Service Bulletin

Bulletin No.: PI0887A

Subject: Pulsating/Rotational Noise from Right Rear of Vehicle on Brake Apply

Models: 2012-2013 Chevrolet Cruze
Equipped with Drum Brake (RPO J93)

2965726

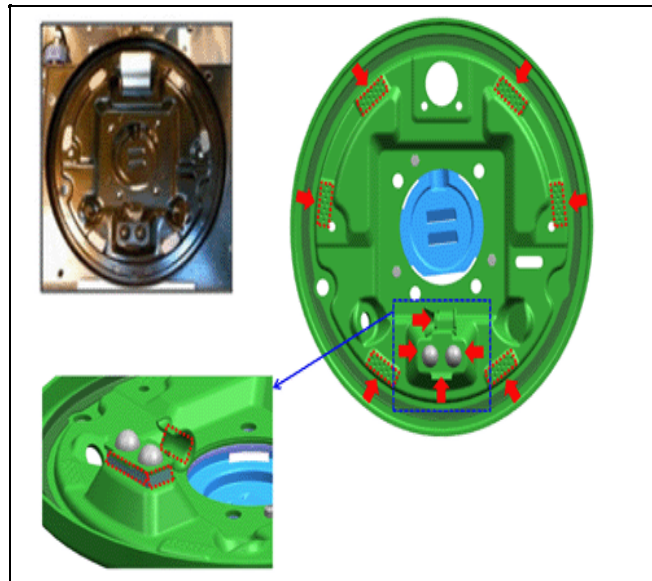
Some customers may comment about a pulsating/rotational noise coming from the right rear of the vehicle during brake apply.

This noise may be caused by an interaction from the cut between the brake drum and brake shoe.

The right rear brake drum and rear brake shoes need to be replaced including applying a high temperature grease, GM P/N 12345996 (in Canada, 10953501), or equivalent, on all the locations of the backing plate as shown in the illustration above.

Note: DO NOT replace the left rear drum and shoes as this noise condition only pertains to the right side.
